# LHAM2

LHAM2

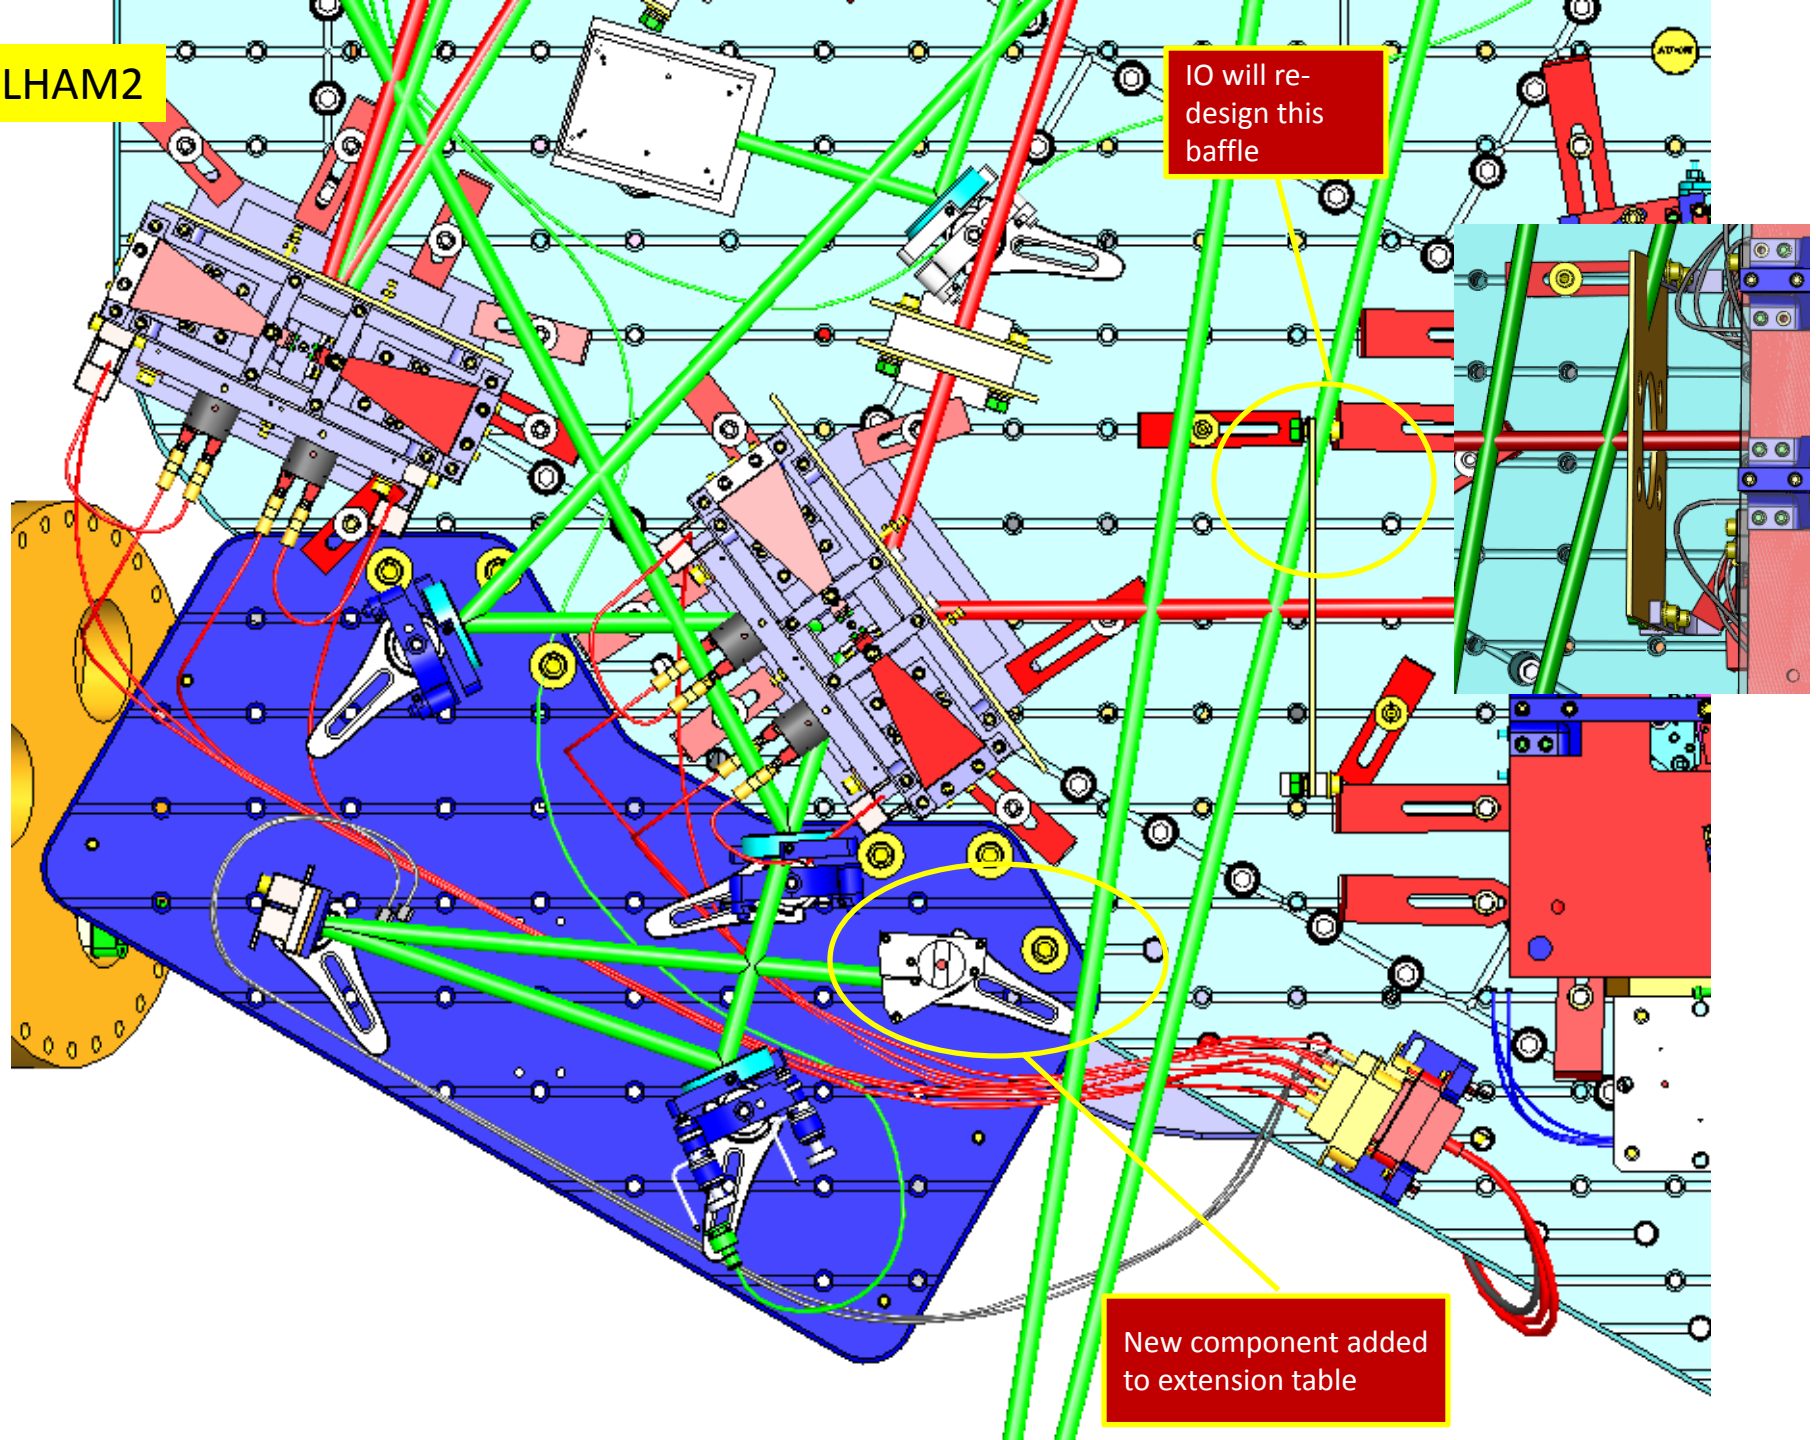
New component added to extension table
